Rezoning Transportation Analysis

Petition Number: #2022-218

General Location Identifier: 04118122 and 04118123

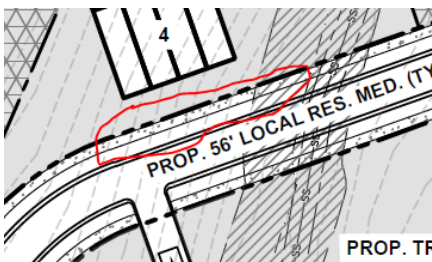
1. ~~Curbline:~~

a. ~~Milhaven Lane:~~ The future location of curb and gutter is in its current location.

~~NOTE: Additional distance from center line to back of curb may be required in locations where a median is present or around intersections and interchanges.~~

~~Label and dimension the curb and gutter from the centerline for each road on the site plan.~~
